VALUE ENGINEERING CHANGE PROPOSAL
MISSOURI DEPARTMENT OF TRANSPORTATION

☒ Conceptual Proposal ☐ Final Proposal Date 4-4-11
Contract ID 110121-301 Job No. 13B0801K
County Pike, Ralls, and Lincoln Original Bid Cost 1,381,789.00
Contractor Lehman Construction LLC By Kenny Lehman
Designed By Kenny Lehman Phone 573-796-8101
VECP# 11-29 (to be completed by C.O.) VECP ☐ or PDVECP ☒

CHANGE ORDER

Subject: Value Engineering Calculations – Temporary Bypass
Contract ID 110121-301
Job No. J3B0801K
Route E, Ralls County

New proposed

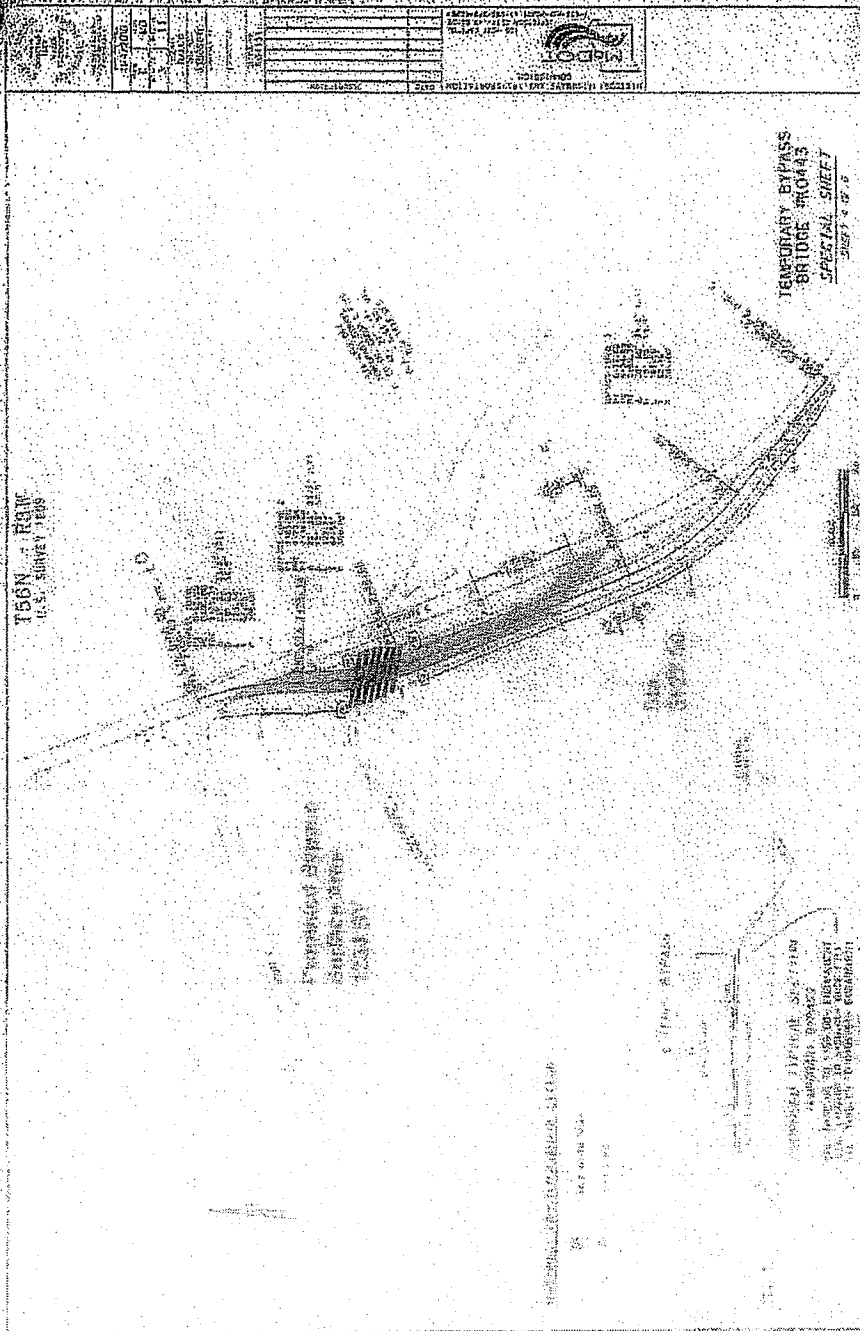
1. Description of existing requirements and proposed change(s). Advantages/Disadvantages
Existing planned temporary bypass on BR04431 on Rte. F in Suverton, MO consist of an approximate surface area of 2029 SY bypass. We propose to shorten this bypass up to an approximate surface area of 1234 SY bypass. We feel this will still allow our crew enough room to stage for this project. By reducing this area it will eliminate approximately 951 CY of embankment, 950 CY of Class A excavation, and 45 ton of Crushed Stone B. (attached are drawings showing route of proposed change).

Comments: The overall length of the designed temporary bypass was intended to allow adequate storage of contractor material & equipment. If the contractor has no concerns associated with less storage area, then I believe this proposal would be acceptable. The south end of the contractor's bypass would have to meet similar curve transitions as the North End through.

Comments: I agree with RE comments. Shortening of the plan bypass is probably doable but the south end transition would still need to provide decent horizontal alignment for traffic to be able to navigate safely. So, quantities probably can be reduced but not as much as contractor has proposed. Will need to field adjust so dollar amount will change.

Comments: Approval is contingent on satisfactory results achieved in the field and written acknowledgement by the contractor that they are responsible for the consequences including unanticipated impacts or delays.

Here is a copy of the Approval concerning the Value Engineering Proposal concerning the Ralls County, Rte. E bypass modification. As per the comments listed in the VE Proposal, reduction in the overall length of the bypass is approved. However, field modifications will be necessary to insure safe navigation for the public. Therefore, the reverse curves at the south end of the bypass will need to match the reverse curves at the north end.
